- Subject** ▶ Change of tapping screws for attaching strain relief.
- For Models** ▶ GA9000, HM1500, HM1500B, HP1310, 900, 910, M900, M910, 9005B, 6905H, 6904VH, 6904H, 6904V, 9006B, 9005BS
- Description** ▶ As described below, tapping screws have been changed to improve strength of Strain relief(housing side).

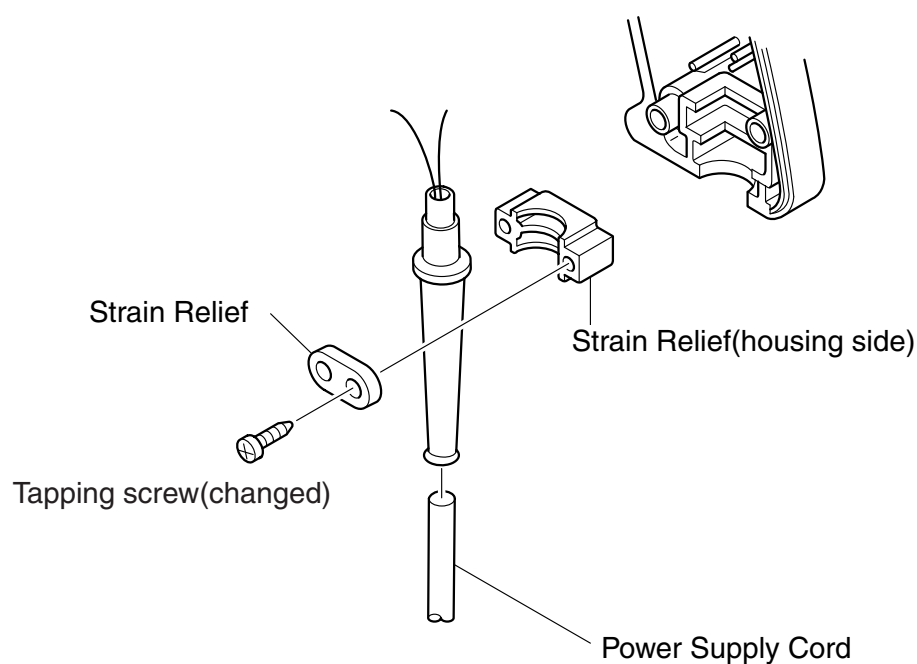
▶ Current	▶ New
BT 4x18 (P.N 265941-9)	MTB (P.N 265995-6)

Item No.	Current part	Q'ty	I/C	New part	Q'ty	Note
	Tapping Screw 4X18 265941-9	2	<=	Tapping Screw 4X18 265995-6	2

<Note> Interchangeability mark : <= means that the new part can be substituted for the current.
